Radio Display

This bulletin involves replacing the radio.

2004 (ZH) Crossfire (United States Market)

Fig. 1 NEGATIVE DISPLAY RADIO

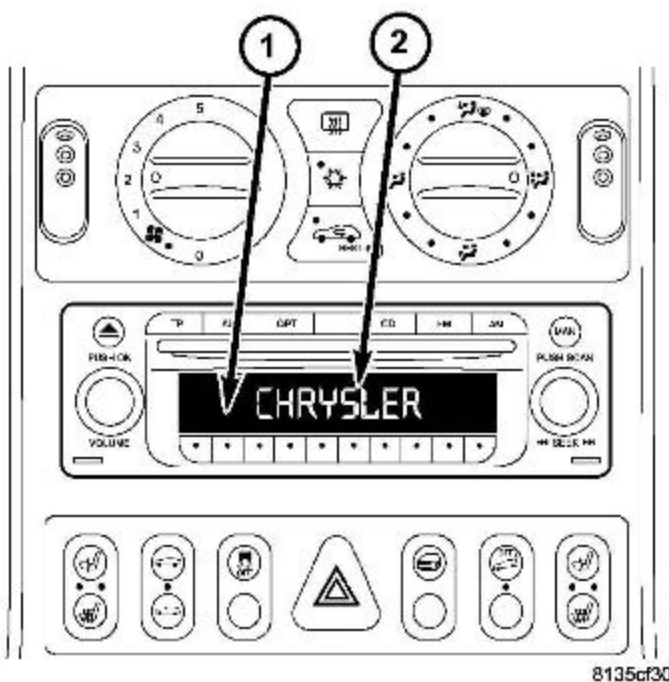
The vehicle operator may describe the radio display as dim and hard to read in bright sunlight.

1. Turn the ignition to the RUN position. Do not start the engine.
2. Turn on the radio and observe the display.
3. If the radio display is a dark background with light characters (negative display), perform the Repair Procedure (Fig. 1).

NOTE: The radio that the technician receives in exchange for the Z5114034AA radio, will be a p/n 05114034AB radio, which will feature a revised faceplate display.

Fig. 2 POSITIVE DISPLAY RADIO

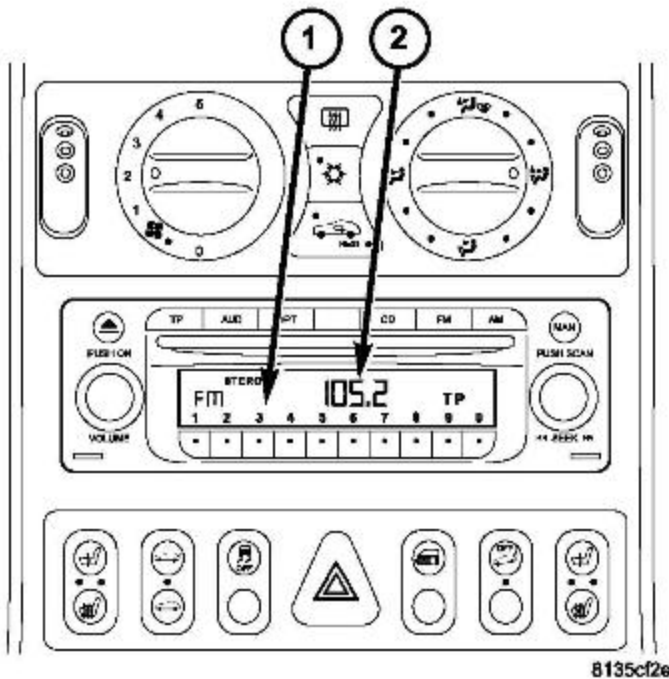
4. If the radio is a light background with dark characters (positive display), further diagnosis is required and this bulletin does not apply (Fig. 2).
